# COMMUNITY DEVELOPMENT DEPARTMENT REPORT

HEARING 1/27/2026  
DATE:  
TO: Mayor & City Council  
FROM: Linda Ritter, Associate Planner  
208-884-5533  
lritter@meridiancity.org  
APPLICANT: Ben Thomas, Civil Innovations, PLLC  
SUBJECT: FP-2025-0031  
Hadler Subdivision No. 3 Final Plat  
LOCATION: Located at the intersection of Locust Grove and E. Via Roberto Street on the east side of Locust Grove, in the NW 1/4 of the SW 1/4 of Section 5, Township 2N, Range 1E.

**B. Final Plat (date: 11/19/2025)**

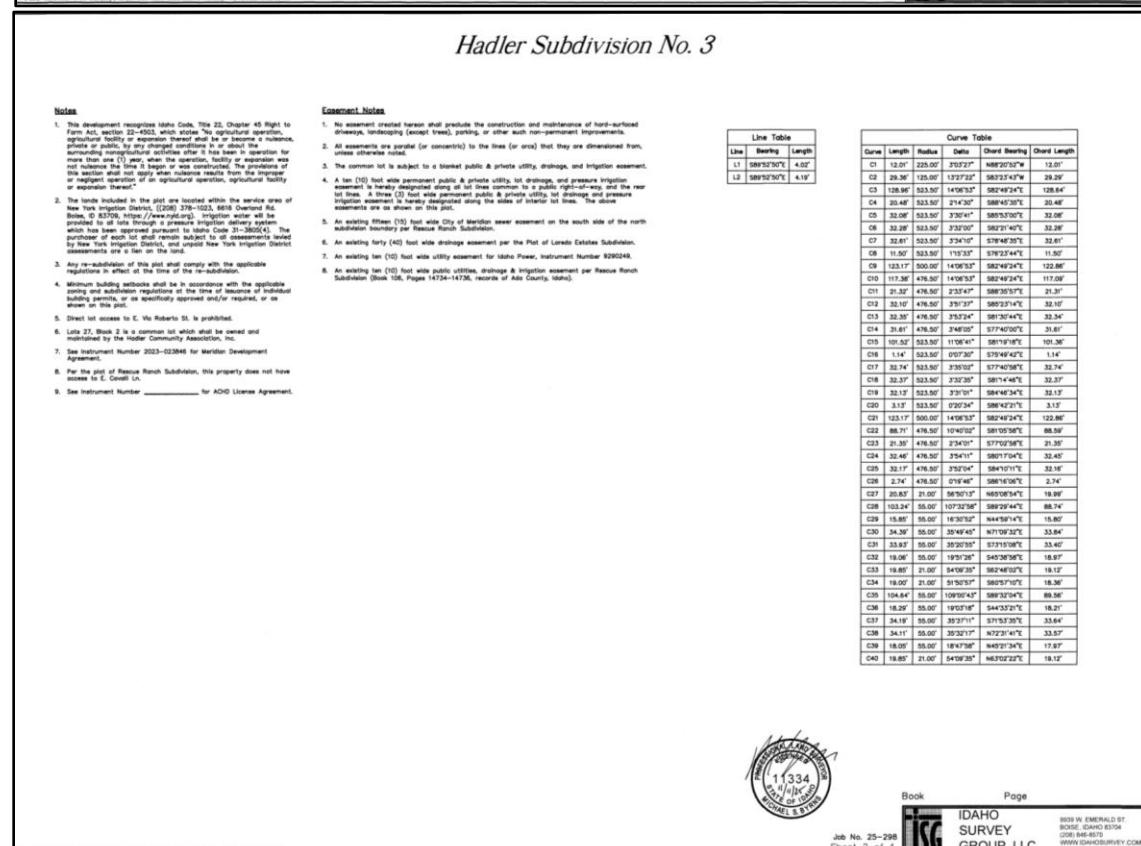
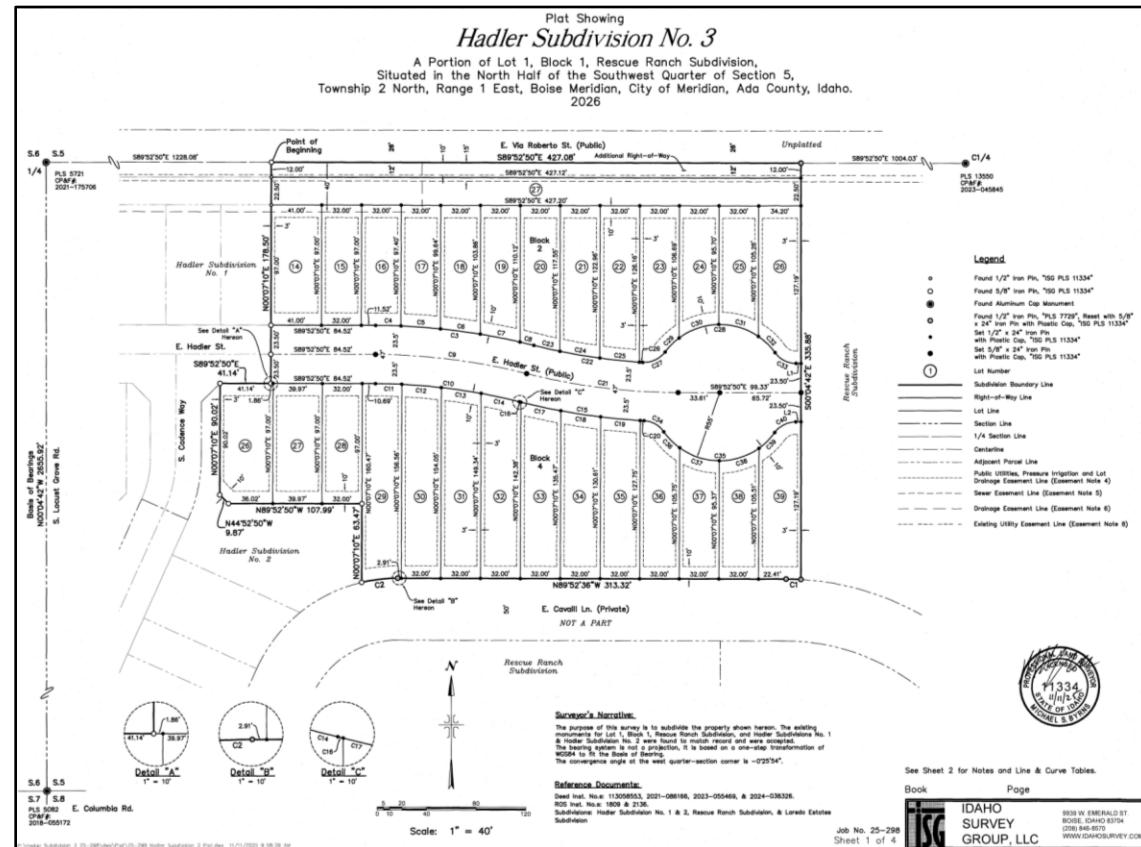
2. The final plat shown in Section V.B, prepared by Idaho Survey Group, LLC, stamped on 1/13/25 by Michael S. Byrns, shall be revised prior to signature on the final plat by the City Engineer, as follows:

- a. Note #9: Include the instrument number for the ACHD license agreement.
  - b. Per UDC 11-2A-3H, in no case shall a development propose less than a five-foot setback adjacent to a property that is not part of the development application and properties shall provide adequate area to maintain drainage on the site. Revise the plat map to show a larger easements on Lot 26, Block 2 and Lot 39, Block 4.

## D. Landscape Plan (date: 11/19/2025)

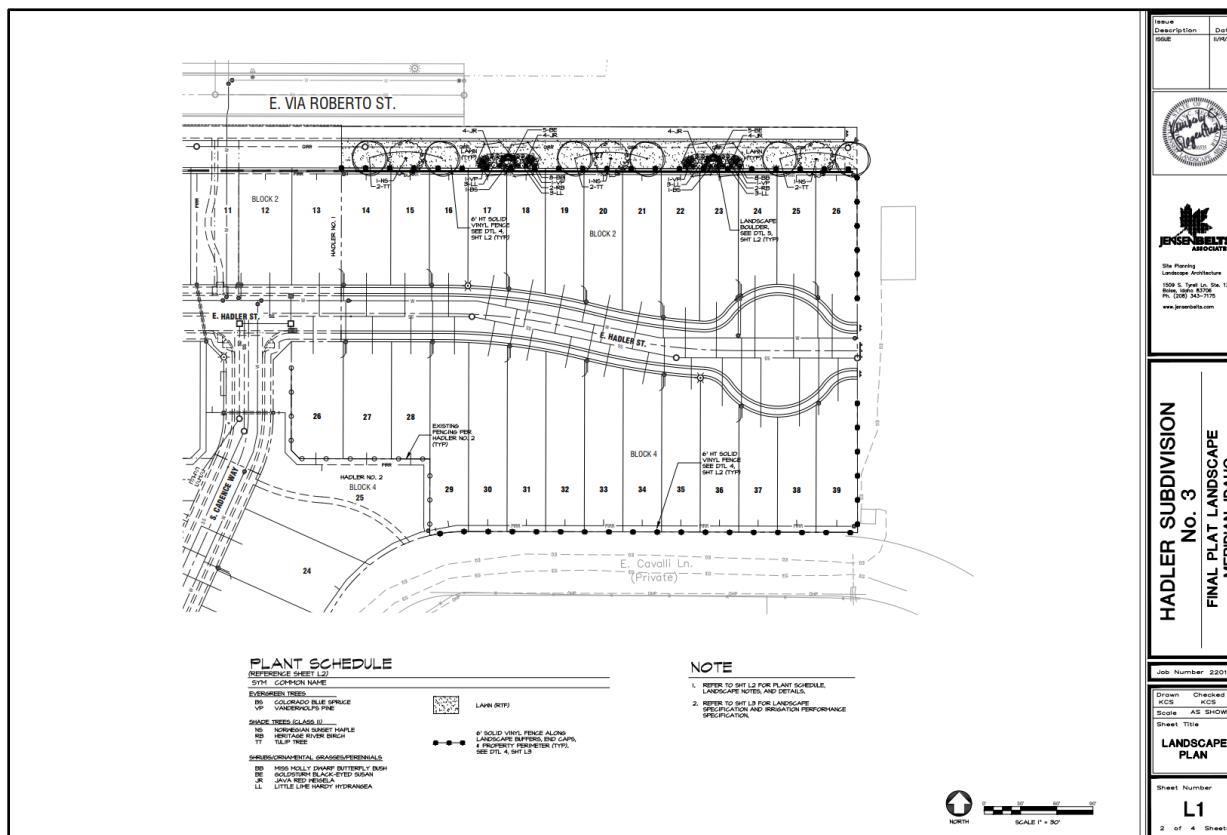
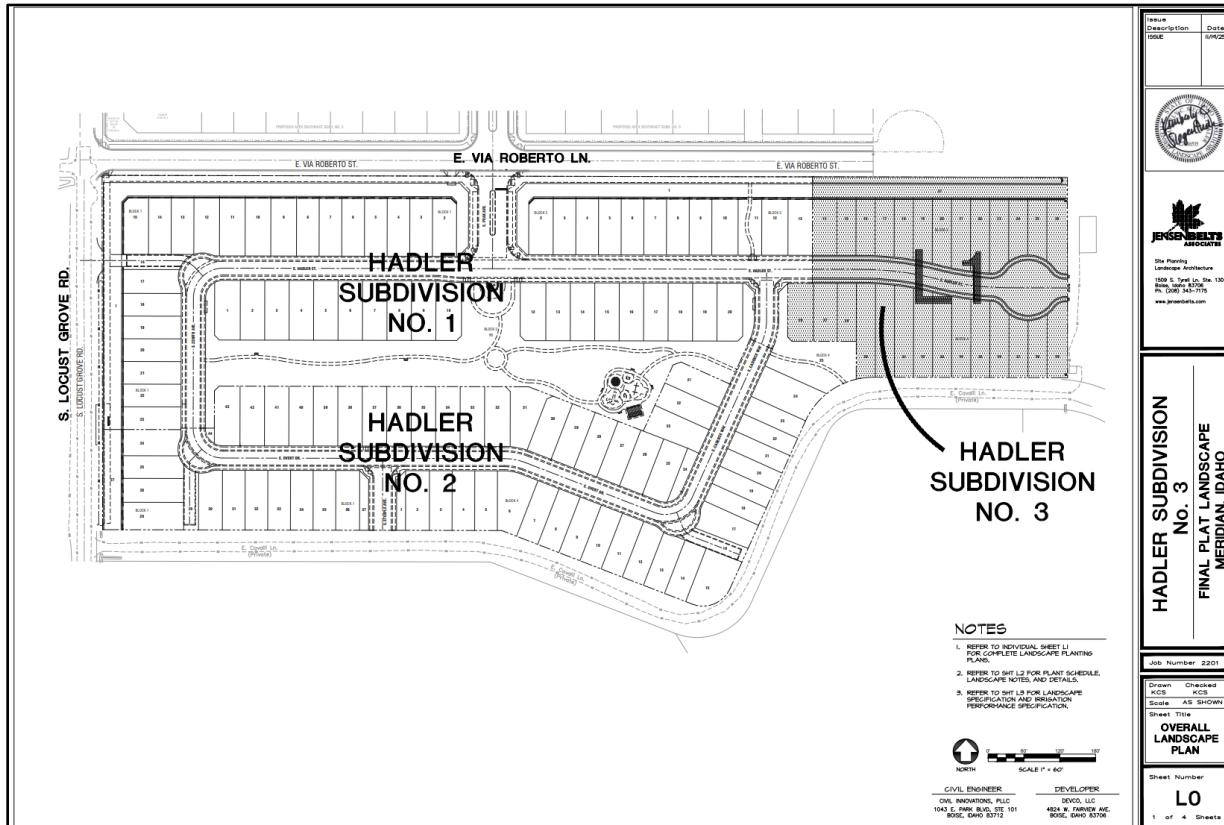
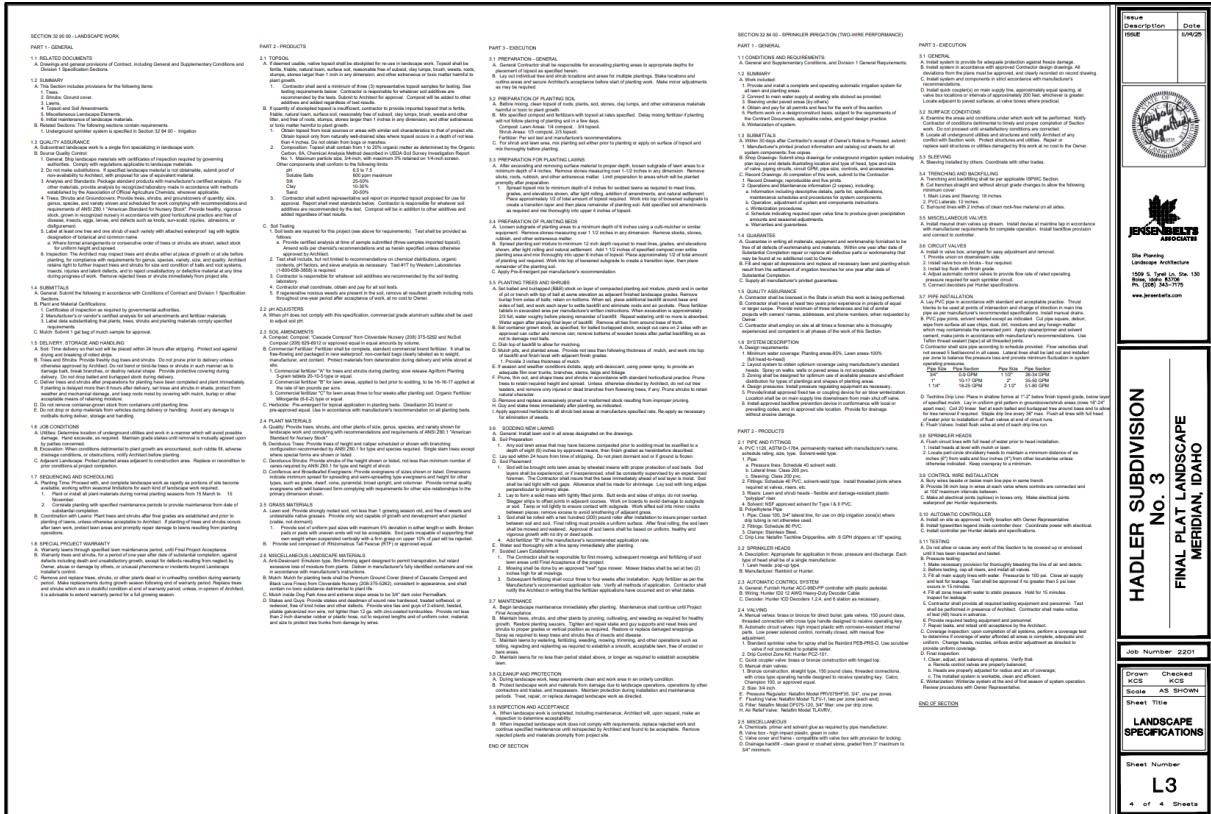
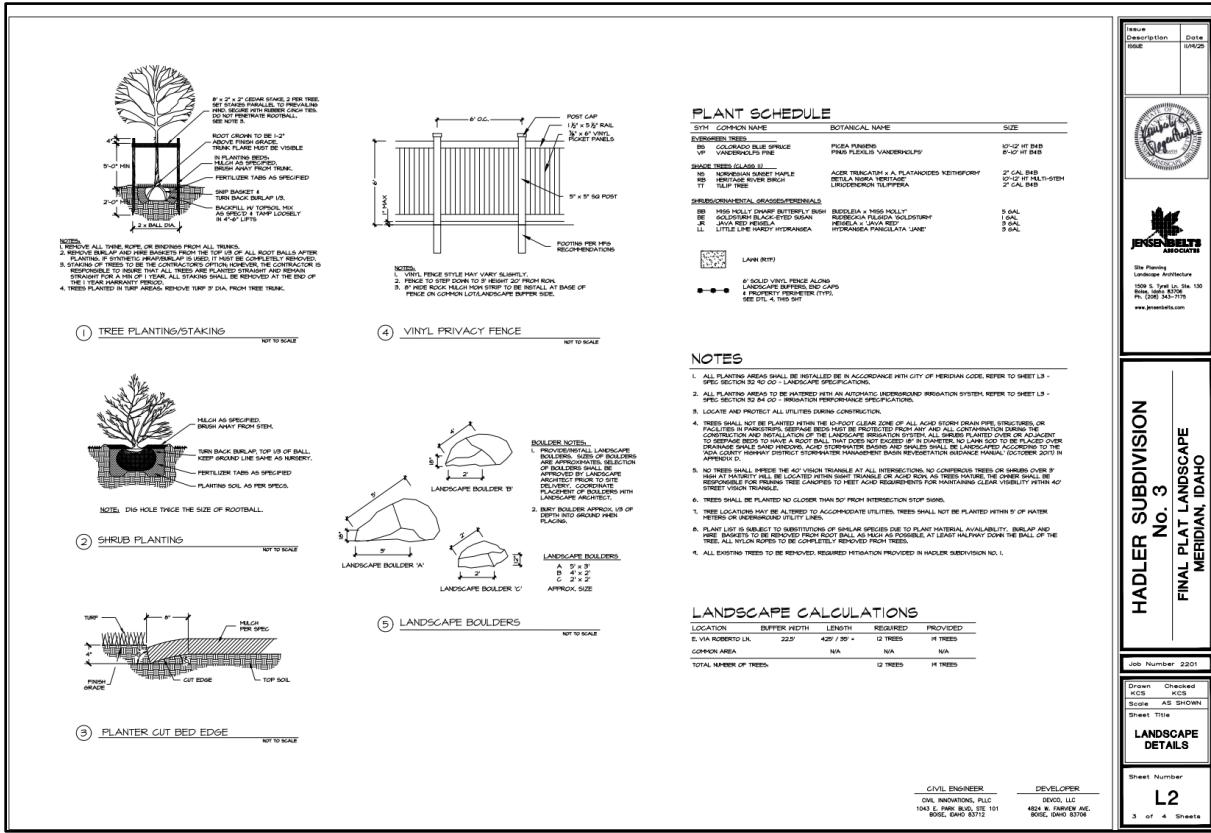
3. The landscape plan prepared by Jensenbelts Associates, dated 11/19/25, shall be revised as follows:
  - a. Revise the landscape plan to show the grassy area in front of the detached sidewalk along E. Via Roberto Street.
